Masunaga Seawall

**APPLICATION FOR SHORELINE SETBACK VARIANCE  
AND  
FINAL ENVIRONMENTAL ASSESSMENT**

**Reconstruction of Seawall**

Masunaga Property, TMK (1) 6-8-10:26 (Lot 11 )  
68-705 Farrington Highway, Mokuleia, Oahu, Hawaii

Figure 2

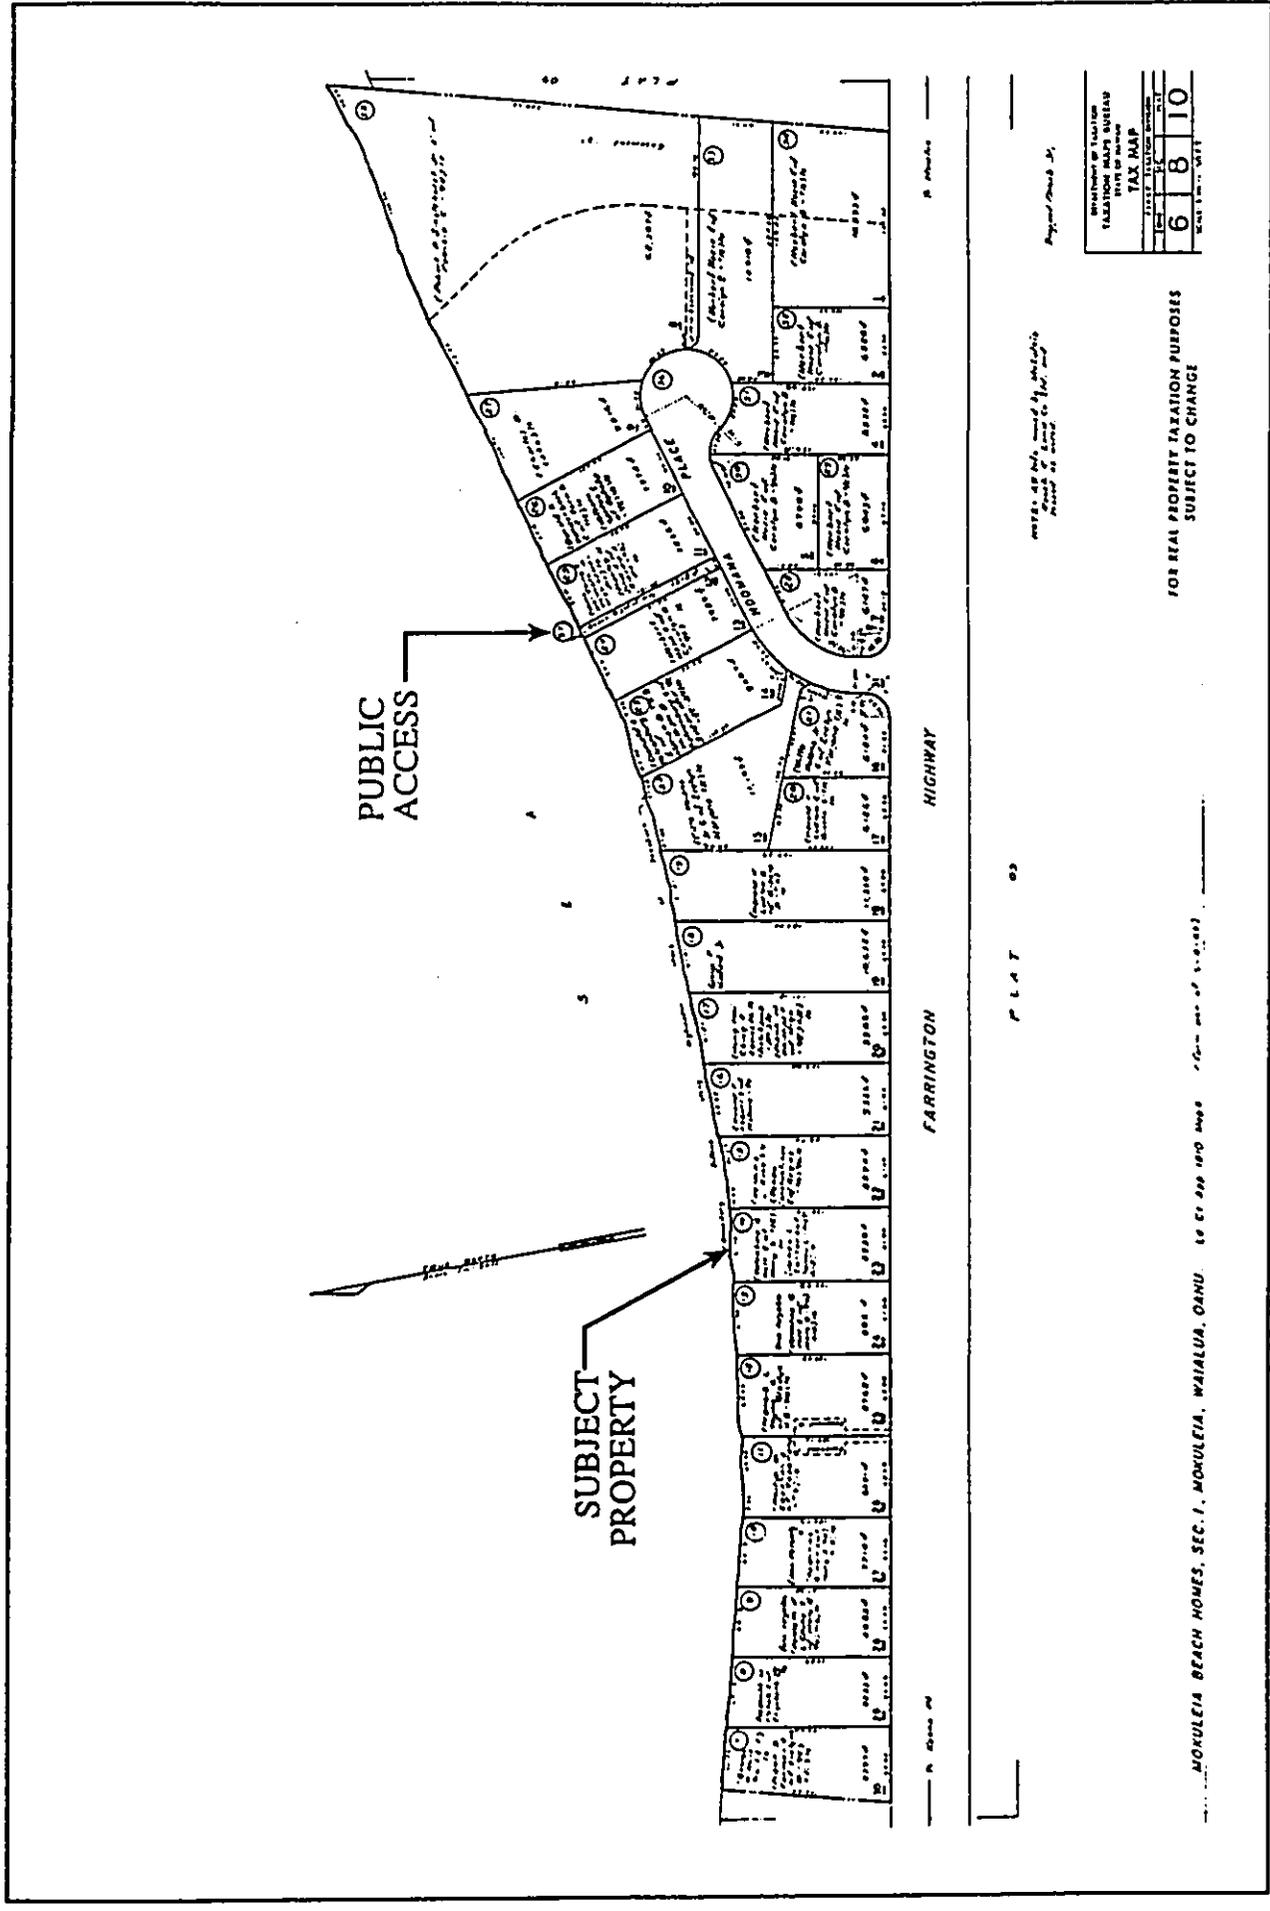
3. Site maps that clearly show the current certified shoreline, previous certified shorelines, the private property line and the location of the proposed structure. Any nearby public access right-of-way should also be depicted.

- 1) **Pubic Access.** The closest public access right-of-way is depicted in the TMK map shown in Figure 2. An access easement is found approximately 500 feet to the east off Ho'omana Street.

Typical CRM  
Modified Seawall Section  
Source: TNWRE, 1997

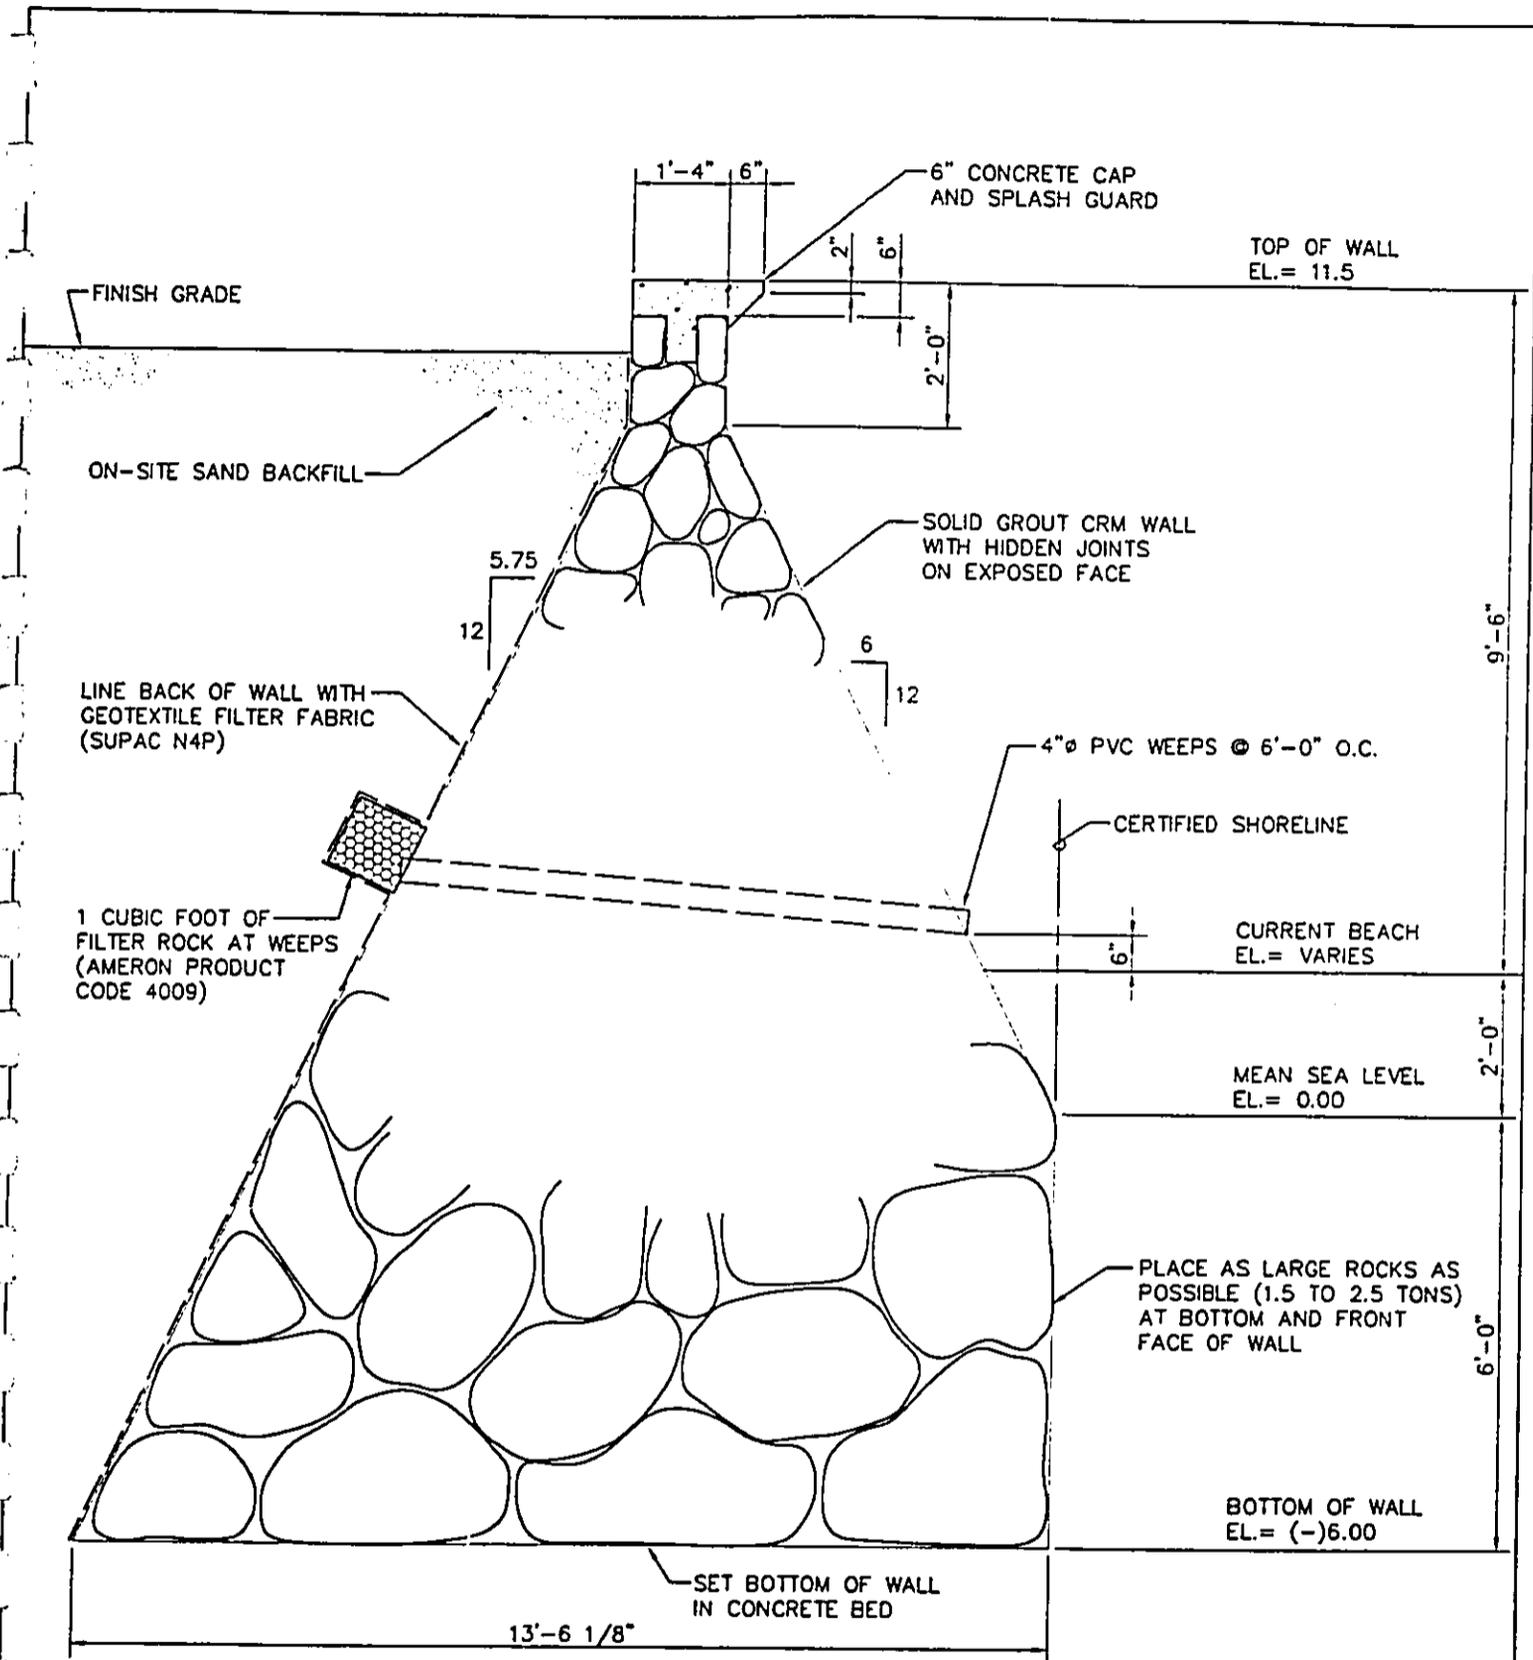
Figure 7 in the DEAs illustrate the design of the proposed seawall structures. The tops of the proposed seawalls are only 1' 10" wide. This hardly seems adequate to allow "safe" lateral access to the shoreline especially during times of high surf events. The proposed seawalls should be designed to allow shoreline access without presenting a safety hazard to the public.

2. **Lateral Shoreline Access.** The four seawalls are aligned together and match the adjoining properties on either side. At this location, there are 16 properties in a row that are all protected by vertical seawalls. The beach along this entire section of the Mōkuleia coast could be considered very narrow. Lateral passage along this shoreline in front of the seawalls will be improved by the proposed action, which will remove loose rock debris and deteriorated wall sections, and replace these with an engineered modified vertical seawall structure. With the lower sloped portion consisting of large rock material, there will be a return of a slightly wider beach for lateral passage. At the three lots to the west where modified vertical seawalls were recently built with the hybrid wall design, there has been a recent return of a narrow strip of beach sand along a section where there was no beach sand for lateral passage in the recent past.
